**Low-voltage switchgear and controlgear assemblies - Part 5:
Assemblies for power distribution in public networks
(IEC 61439-5:2023/COR1:2025)**

The text of the corrigendum IEC 61439-5:2023/COR1:2025 was approved by CENELEC as EN IEC 61439-5:2023/AC:2025-02 without any modification.

IEC 61439-5
Edition 3.0 2023-05

C O R R I G E N D U M 1

Figure 107 – Diagram of test to verify the mechanical strength of doors

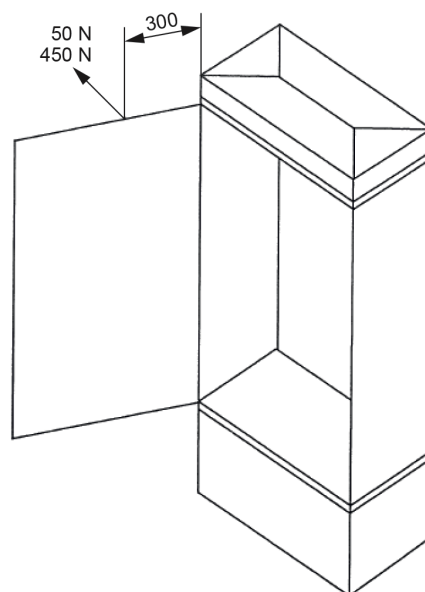
Replace Figure 107 with the following:
